2016SYE122 – 678-682 Kingsway Miranda

DA16/1411

ASSESSMENT REPORT APPENDICES

Architectural Review Advisory Panel

Figure 1: Section showing extent of height non-compliance (highlighted in yellow)

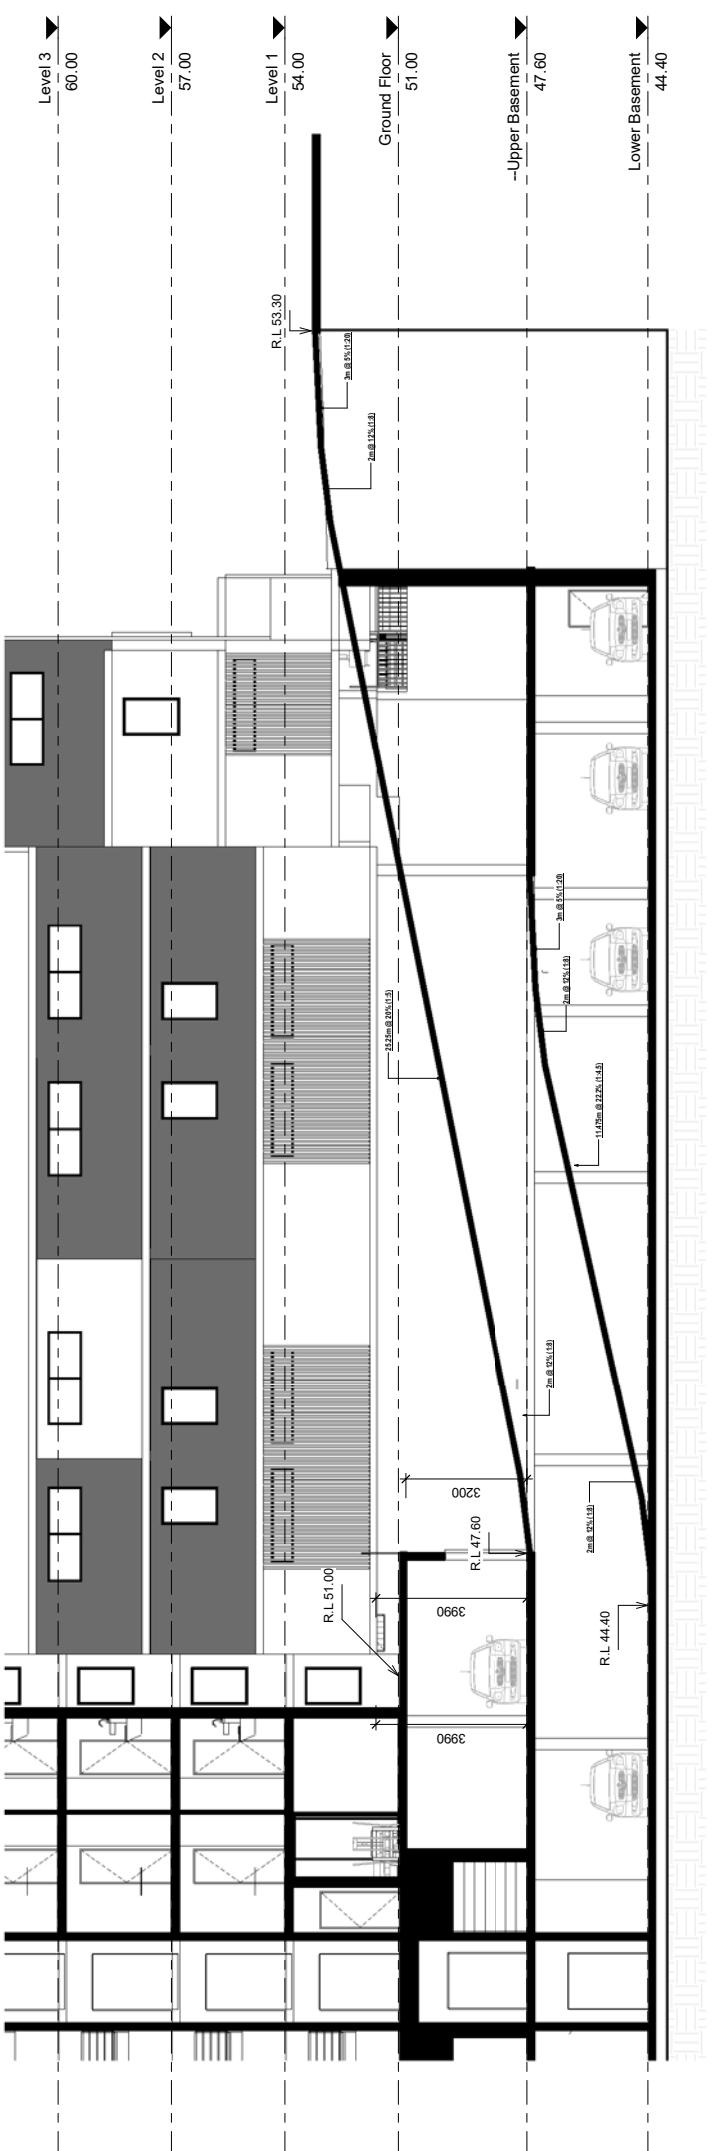
As indicated in the section plan included in Figure 1 below, the proposed roof slab and the lift/stair core on the northern building breach the maximum height. The height breach is a maximum of 28.3m limited to the lift overrun and 25.5m to a portion of the building on the eastern elevation. Other portions of the buildings comply with the maximum LEP height control for the site.

The proposed encroachment into the maximum building height is considered to be minor and will not substantially change the appearance of the proposal within the locality, nor will the additional height be readily apparent or obvious to the casual observer at street level or from adjoining properties.
